SUBJECT: Response to NRC Request for Additional Information (RAI) Regarding Materials Reliability Program (MRP)-169, "Technical Basis for Preemptive Weld Overlays for Alloy 82/182 Butt Welds in PWRs"

PROJECT NUMBER: 689

MRP Letter 2007-053

NRC RAI Response

Figure A-1 – Post-Overlay Axial Residual Stress Comparison (Surge Nozzle vs. PWOL Mockup) at 70°F

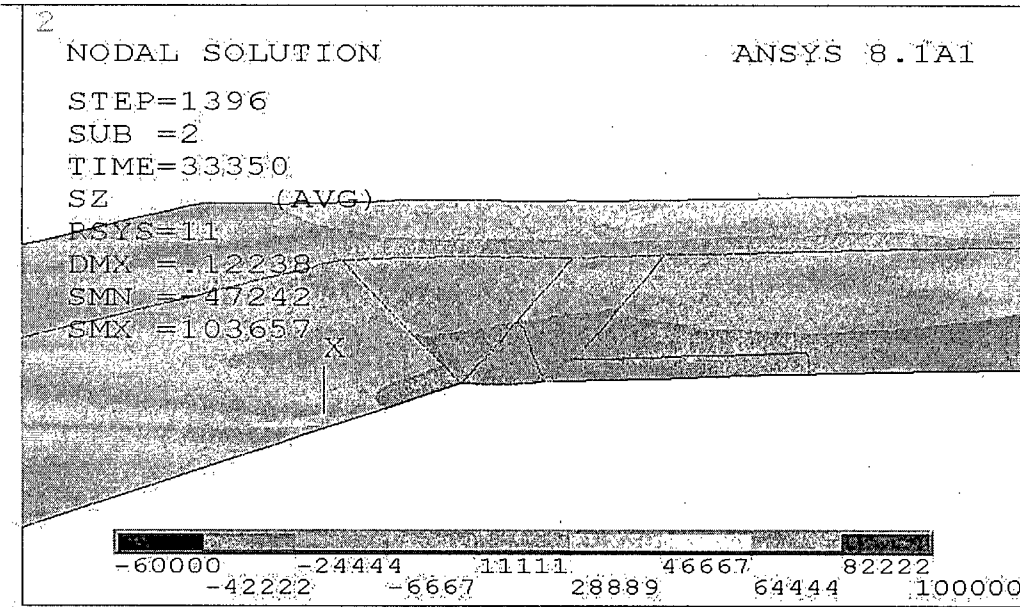
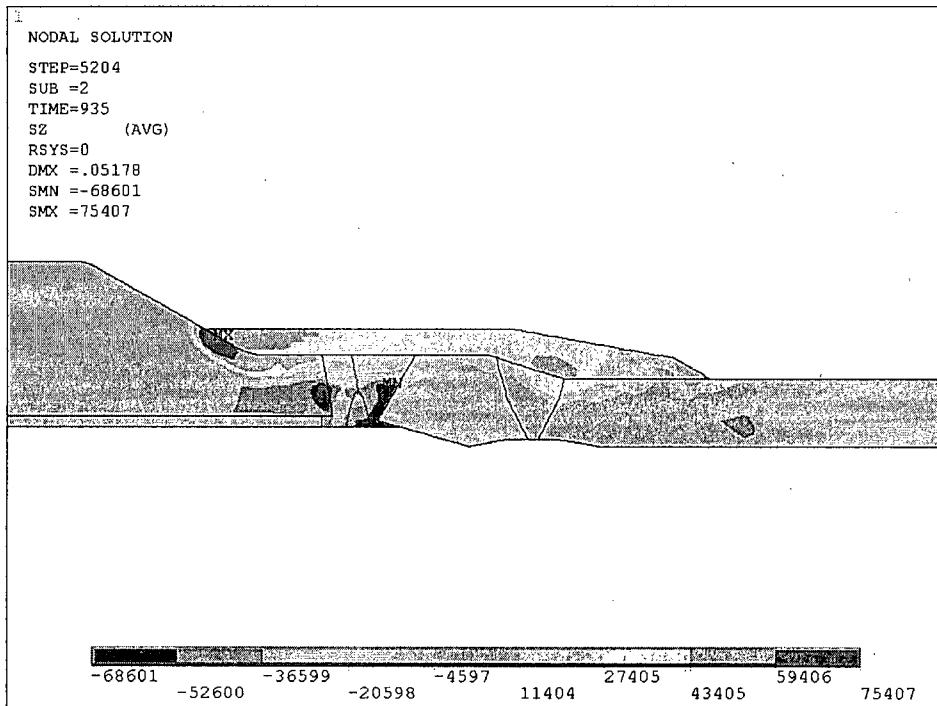
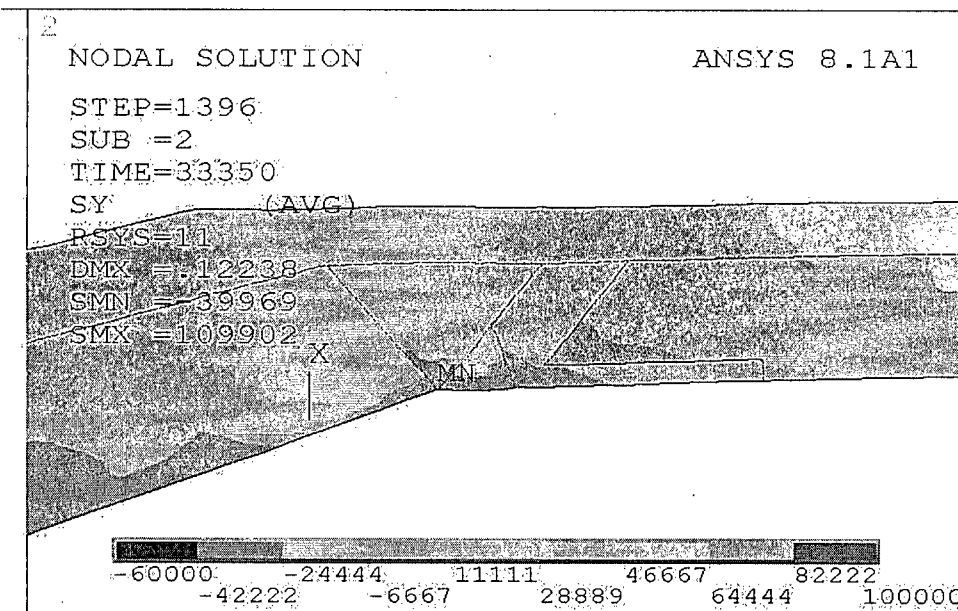
Stress Analysis Question 4 *Figures 5-11 and 5-12 show the residual hoop and axial stress distributions for the PWOL mockup. After application of the PWOL, the residual hoop and axial stresses in the WOL appear to be mostly compression. In addition, prior to the application of the PWOL, the figures indicate high tensile hoop and axial stresses that may be beyond the ultimate stresses of the materials. After application of the PWOL, the high tensile regions in the nozzles become compressive, but the compressive regions appear to remain compressive. The stresses in the WOL*

are also shown mostly as compressive. Figures 8-8 and 8-9 show the residual stress distribution for a pressurizer spray nozzle, which appears to be similar to the mock-up geometry. The stress distributions are different from those of the mock-up nozzle. Likewise, the T-W stresses shown in Figures 8-11, 8-13 and 8-15 tend to be tensile towards the outer surface, as expected.

4.a) Provide a discussion why the stress distributions in the mock-up PWOL are different from those of the nozzle PWOLs in Section 8.

Proposed Response (4a) The PWOL mockup actually more closely simulates a surge nozzle than a pressurizer spray nozzle. The spray nozzle is smaller in diameter and is relatively thicker (smaller radius to thickness ratio). The post-overlay residual stresses for the mockup in Section 5 and the surge nozzle example in Section 8 do not differ significantly, when compared under like conditions.

Appendix A to this response provides contour plots of axial and hoop post-overlay residual stresses at 70°F for the surge nozzle example of Section 8 and the PWOL mockup of Section 5. Careful examination of these plots indicates that the residual stress distributions for the two are quite similar, when compared under like conditions.

Figure 4-1 – Schematic Illustration of ASME Section XI Flaw Evaluation Basic Concept

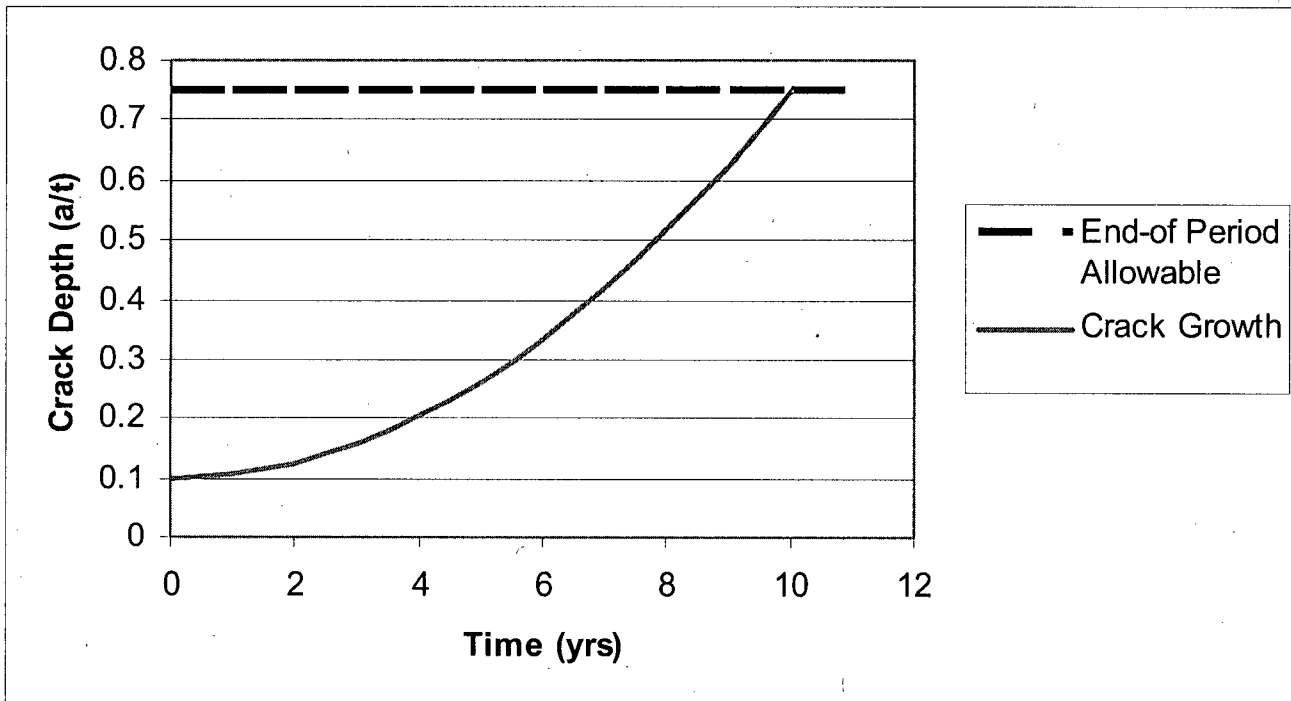
Inspection Question 4 *In Section 4-4, the discussion of ASME intervals and “that interval” for allowable flaw sizes on Page 4-6 is confusing. Please provide a few examples for subsequent ISIs using the criteria you discuss.*

Proposed Response The wording of Section 4-4 will be changed for added clarity.

The wording in Section 4.4 regarding subsequent inspection intervals has been revised for clarity, and an example, based on new Figure 4-1 is discussed.

Figure 4-2 – Illustration of Full Structural and Optimized Weld Overlay Design Basis Flaw Size Assumptions

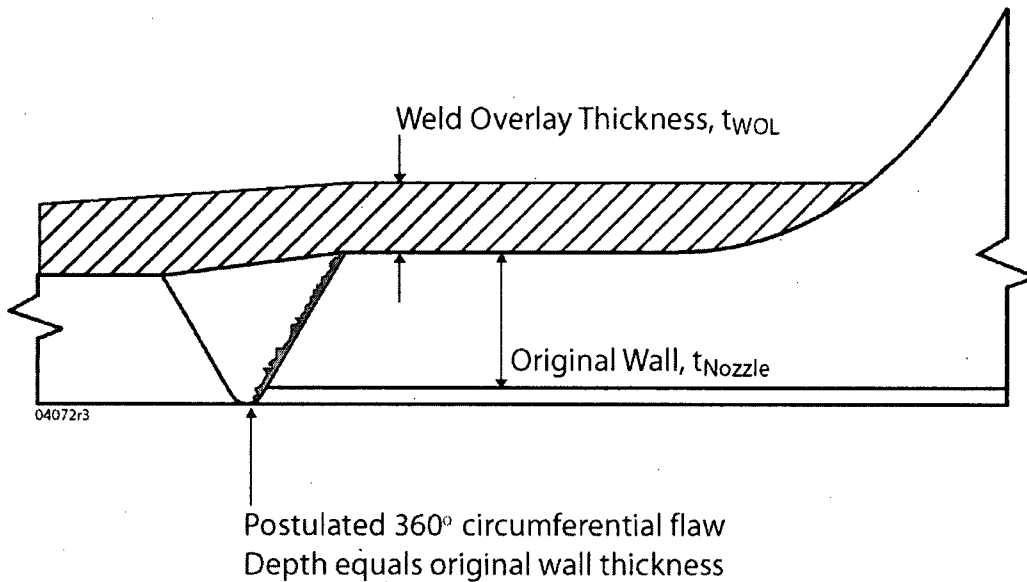
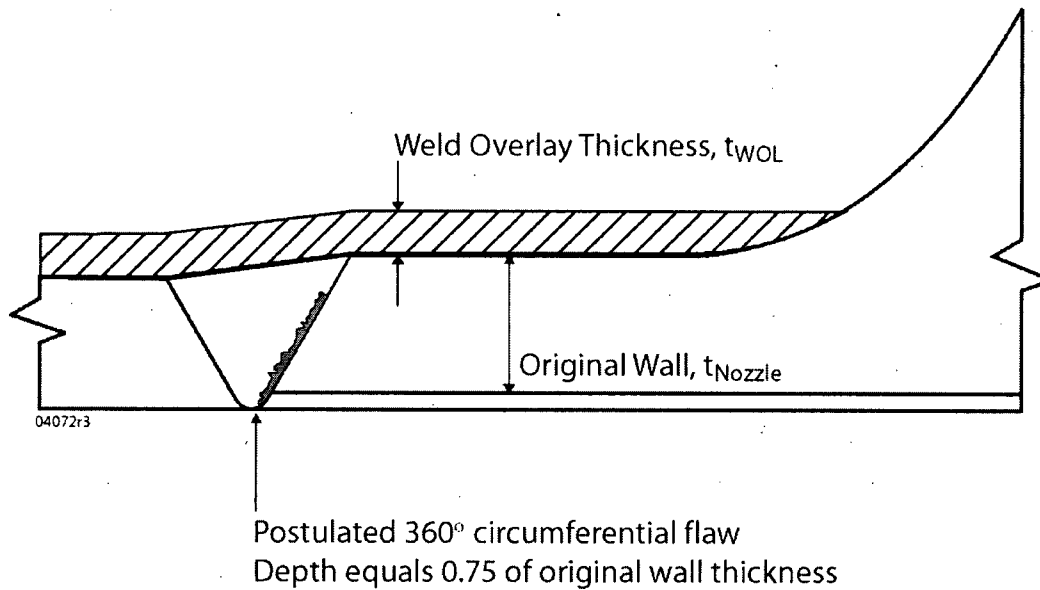
General Question 2 *The treatment of pre-emptive full structural, design, and optimized weld overlays (WOLs) is confusing because in various sections the discussions of the design and optimized pre-emptive weld overlay (PWOL) are intermingled with the discussion of the full structural PWOL. The NRC staff suggests that the report be clarified to (a) provide an introductory section that defines the differences between full structural, design, and optimized WOLs and (b) more clearly separate out the differences in the design and inspection rules for each category of overlay.*

75% of the original pipe wall. An illustration of the design basis flaw size differences for full structural and optimized overlays is provided in Figure 4-2.

Figure 5-14
Comparison of Analytical vs. Measured Hoop Residual Stress Results for PWOL Mockup

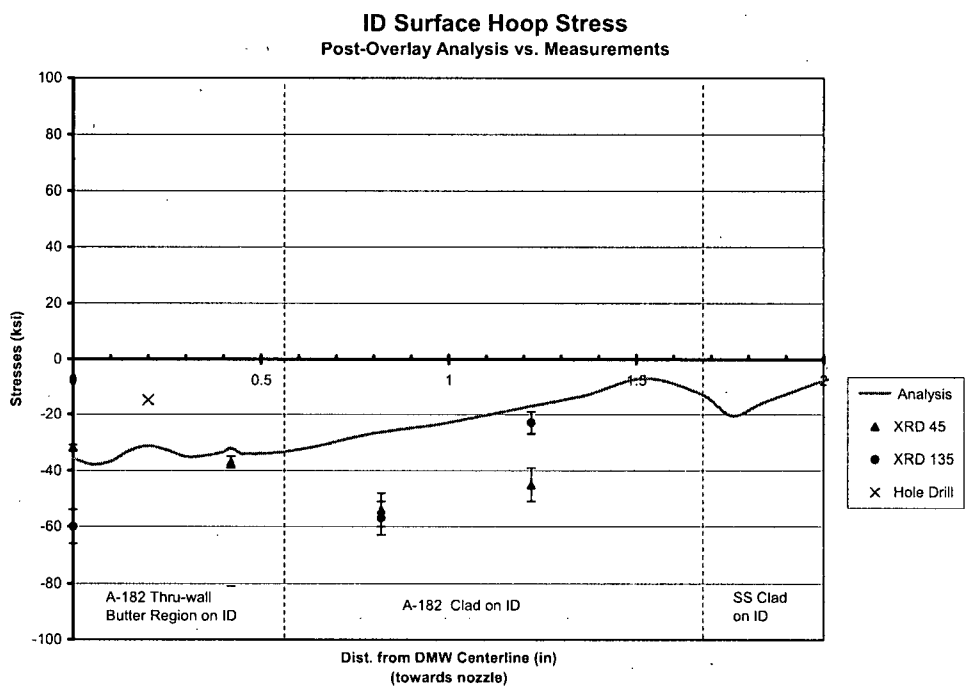
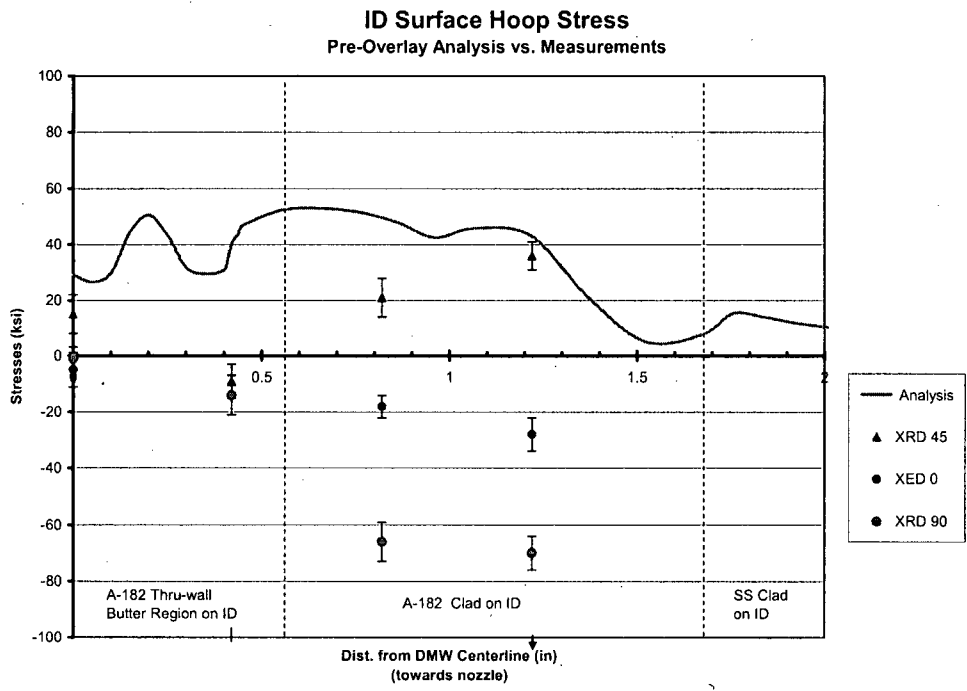
WOL Effectiveness Question 1 *Section 5.1 on Page 5-4 discusses the “MRP/EPRI PWOL Development Program for Alloy 600 [primary water stress corrosion cracking] PWSCC Mitigation.” This section indicates that the program is on-going and that the analysis results are preliminary. Please provide the status of this program and the final results.*

Section 5.1 (5) was completely re-written and Figures 5-12 thru 5-15 added summarizing the results of the PWOL mockup program.

Figure 7-3

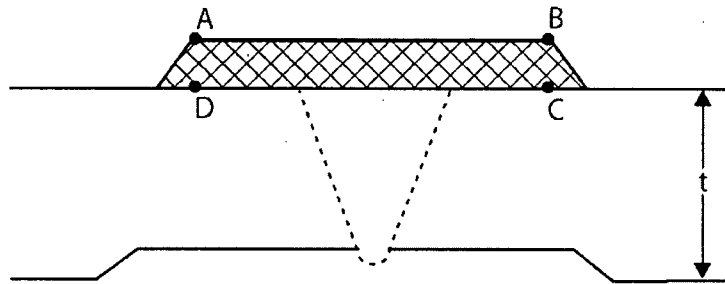
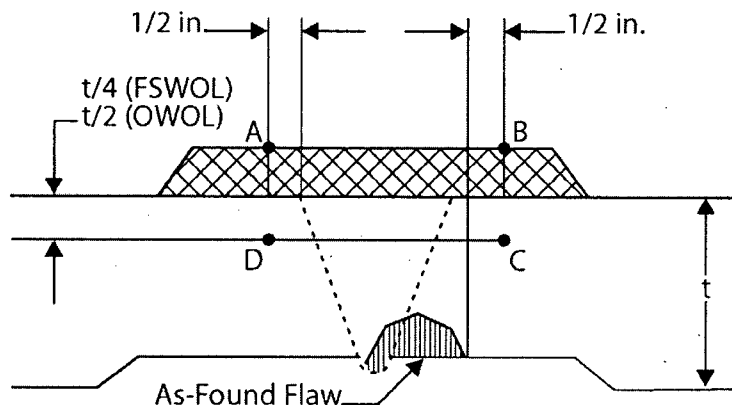
Inspection Question 5 *The fourth paragraph in Section 7.1 discusses construction examination of a WOL on piping that is normally examined from the inside surface for ISI. The construction examination is the overlay volume. The criterion is silent on examination of the heat affected zone. Provide an explanation for excluding the heat affected zone from the examination of the WOL. The same paragraph is silent on performing examination from the inside surface prior to applying the WOL. If a crack is located on the inside surface, how effective would depth sizing be after applying the WOL. Discuss why an examination prior to applying the WOL is or is not necessary. Discuss the monitoring of an inside surface crack from the inside surface at a location with an outside surface WOL.*

Inspection Question 7 *Section 7.2.1 states that if an ISI examination immediately prior to a full structural or optimized WOL that is absent of any flaws or crack-like indications, then future ISI of the WOL shall be performed in accordance with requirements of Section XI of the ASME Code. What are the specific ASME Code, Section XI non-destructive examination (NDE) methods and volume and/or surface examination requirements? Do the examination requirements of Section XI, Appendix Q of the ASME Code apply?*

Proposed Response The required exam volume for the acceptance (construction) examination of the overlay includes the entire weld overlay (except for the tapered end regions) and the associated HAZ. This inspection is performed from the OD of the overlay regardless of whether pre-and post-overlay inservice inspections are performed from the ID or OD. Section 7.1 and Figure 7-1 of MRP-169 will be clarified on these points.

Figure 7-1 has been modified to specifically identify the required inspections and exam volumes for post overlay inspection, including the acceptance examination, and pre- and inservice inspections. The wording in Section 7.1 has also been expanded to

A summary of the required examination volumes for post overlay inspections is provided in Figure 7-1. Two separate exam volumes are illustrated, one for the overlay acceptance examination (Figure 7-1(a)), and a second for the overlay pre- and inservice inspections (Figure 7-1(b)).
